**RE:           Application by Canadian Distributed  
              Antenna Systems Coalition ("CANDAS");  
              Board File No.: EB-2011-0120**

**Interrogatories of CANDAS**

**Toronto Hydro-Electric System Limited**

**September 13, 2011**

**Reference:** THESL Letter, paragraph 1

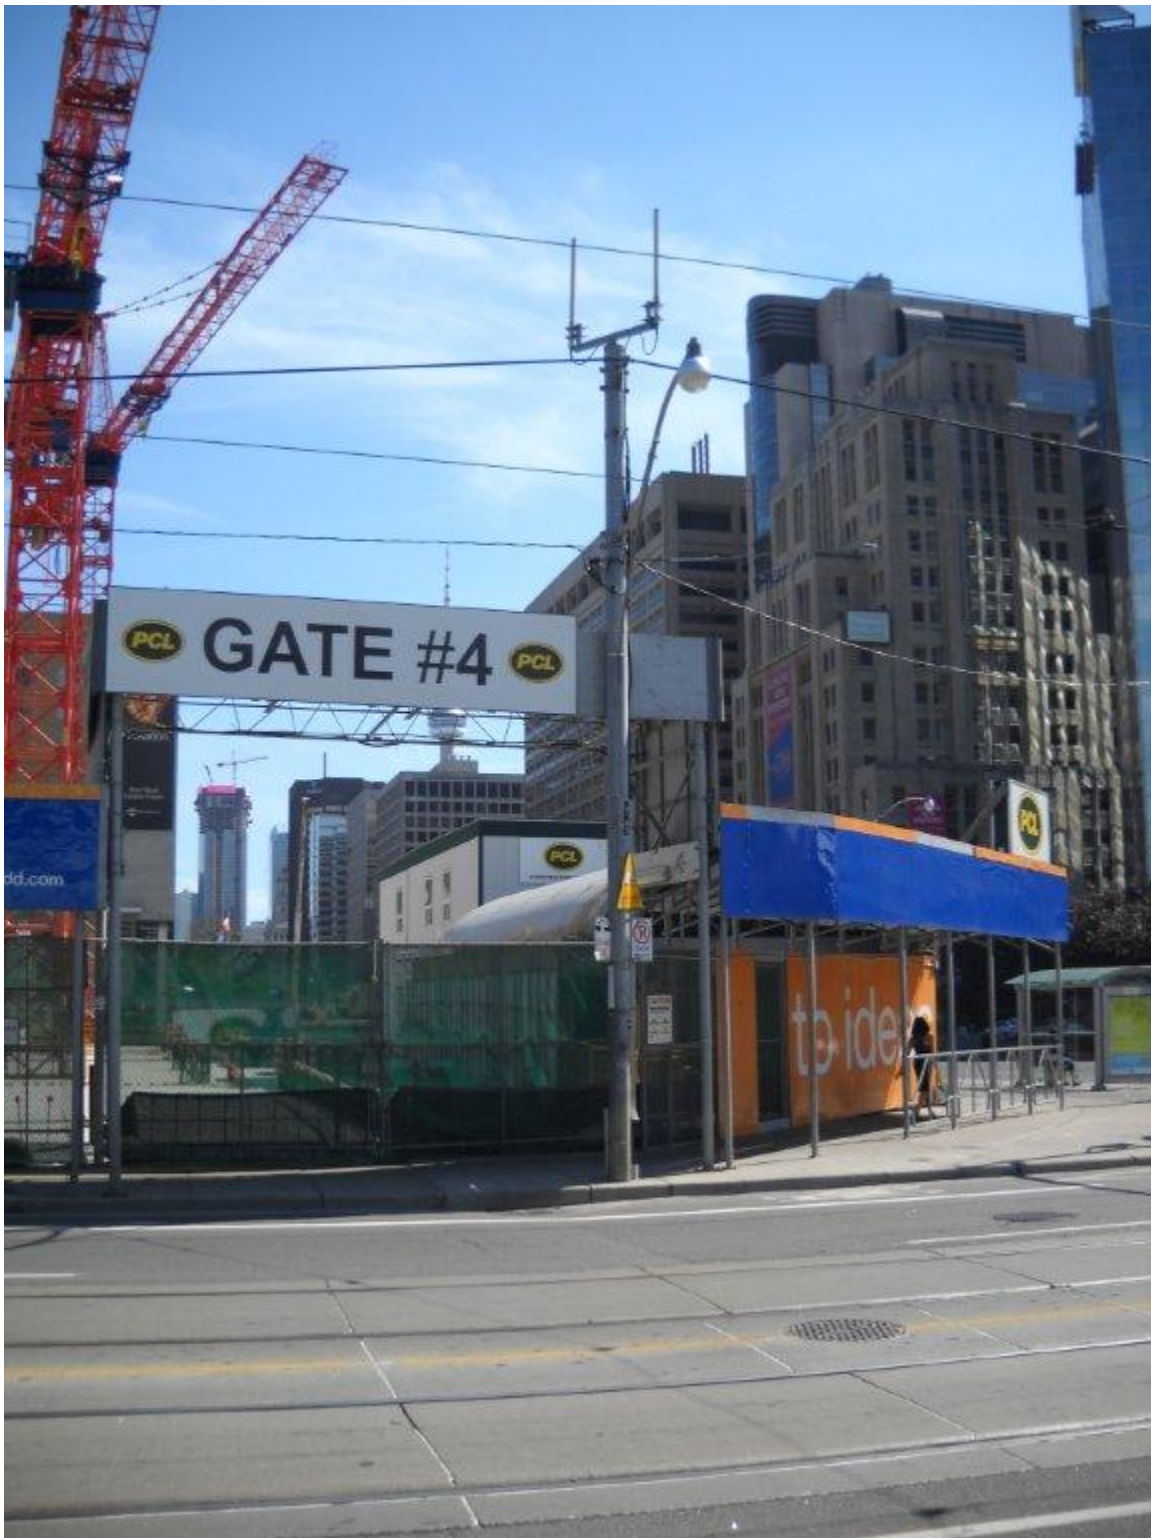
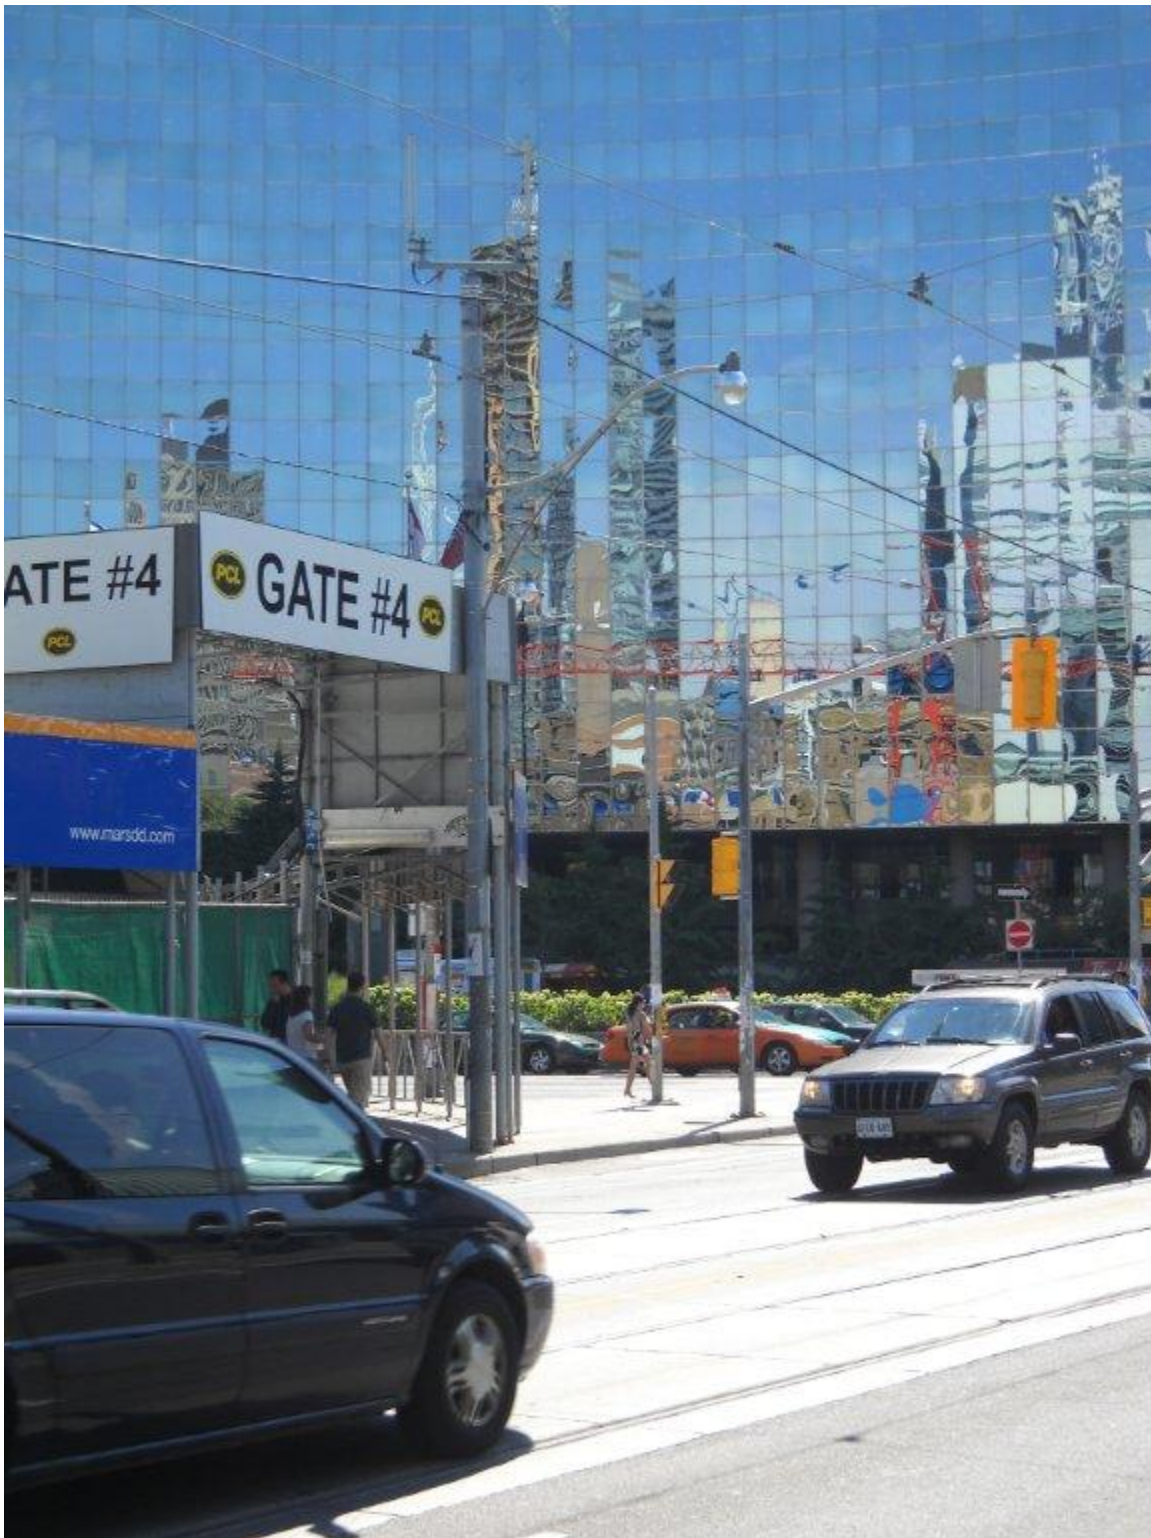
**Preamble:** The THESL Letter states “[THESL] wishes to inform the board that, in light of many safety and operational concerns about the attachment of wireless telecommunications equipment to its pole infrastructure that are set out in this letter and its appendix, THESL has adopted a policy not to attach such equipment to its poles.” The following questions address a certain pole outside of 700 University Avenue, Toronto, Ontario. Photos are provided for ease of verification.

- (a) Is this pole owned by THESL or by THESI?
- (b) Is this pole a THESI pole or, is it one of the poles that will be transferred to THESL?
- (c) Is the apparatus at the pole top a wireless antenna system?
- (d) Who owns the antenna system attached to the pole?
- (e) If the attached apparatus is permitted by THESL under an agreement, please provide a copy of the agreement that governs this installation.
- (f) Does THESL intend to renew the attachment agreement for this pole when it expires?
